Subject: Notification of Planned Change to the Permitted Facility to Support
TRUPACT-III

**Notification of Planned Change to the Permitted Facility
Waste Isolation Pilot Plant**

Table Listing of TRUPACT-III required penetrations

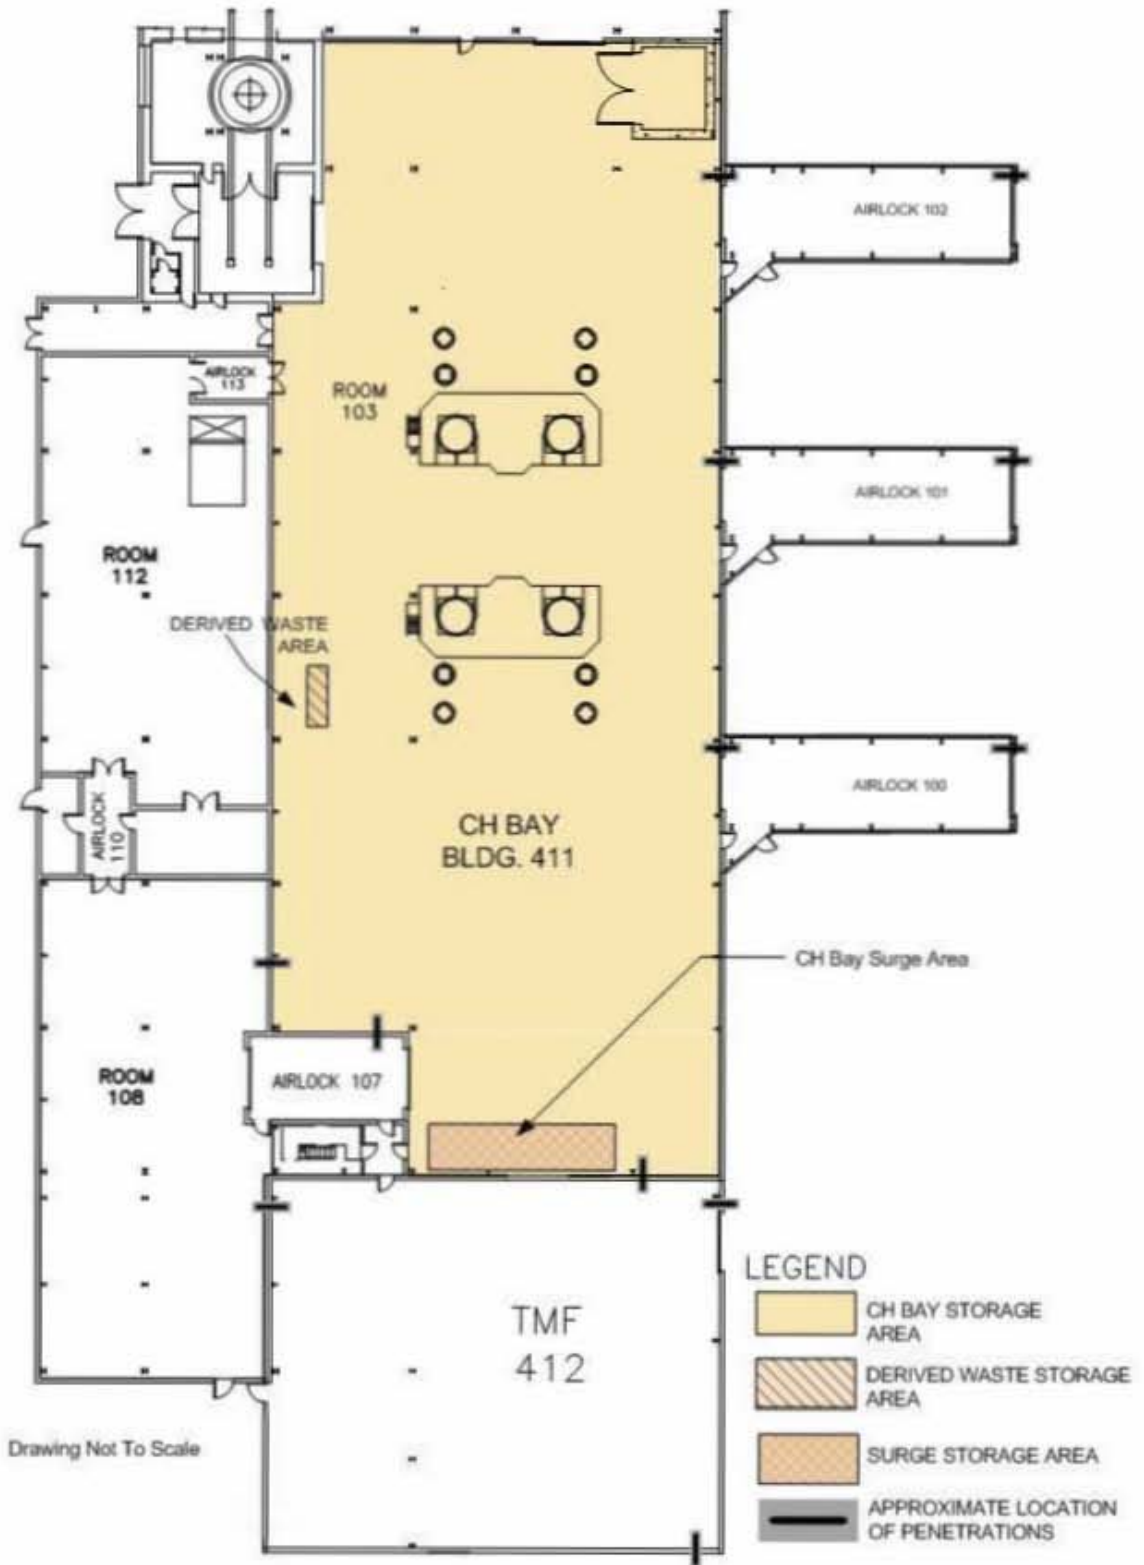
The Permittees have identified 21 wall penetrations listed in the attached table. These are needed for conduit that will be used to connect various components of the electrical, communications and monitoring systems associated with the TRUPACT-III project. The wall penetrations are for conduit access between the Contact-Handled Waste Bay (CH Bay-Building 411) and Airlocks 100, 101, 102, and 107, the TRUPACT Maintenance Facility (TMF, Building 412), and Room 108 of Building 411. The approximate locations of these penetrations are depicted on the attached figure. (Note: The figure has 12 locations for the 21 penetrations.) These penetrations will vary from approximately 1 inch to 2 ½ inches in diameter to accommodate the conduit sizes listed on the attached table. The area around the conduit will be sealed. The conduit will be capped until the wiring is installed at a later date. The capped conduit will not impact the negative pressure differential maintained in the CH Bay relative to the outside atmosphere. The work to install the 21 penetrations will occur during the 2010-2011 maintenance outage.

Some of the penetrations in the TMF are not in the Permitted Facility. These are identified on the attached table with asterisks. To fully describe all the penetrations, the Permittees have included these items in this notification for your information. In the event that additional penetrations are necessary, the Permittees will provide an additional Notification of Planned Change with appropriate details. The following table describes each penetration and its approximate size and location.

Number of Holes	Conduit Size (Inches)	Affected Area	Approximate Location
1	3/4	Airlock 102 - Outside	Adjacent to the roll-up door
1	3/4	Airlock 101 - Outside	Adjacent to the roll-up door
1	3/4	Airlock 100 - Outside	Adjacent to the roll- up door
2	3/4	CH Bay - Airlock 100	Adjacent to the interior roll-up door
2	3/4	CH Bay - Airlock 101	Adjacent to the interior roll-up door
2	3/4	CH Bay - Airlock 102	Adjacent to the interior roll- up door
3*	3/4	TMF - Outside	Adjacent to roll-up door & SW corner of TMF West Wall
2	1 1/2	CH Bay - TMF	Adjacent to the door
3	3/4	CH Bay - Room 108	East of Airlock 107 near battery charging station in CH Bay
1*	3/4	Room 108 - TMF	NE corner of TMF North Wall
3	3/4	CH Bay – Airlock 107	East wall of Airlock 107
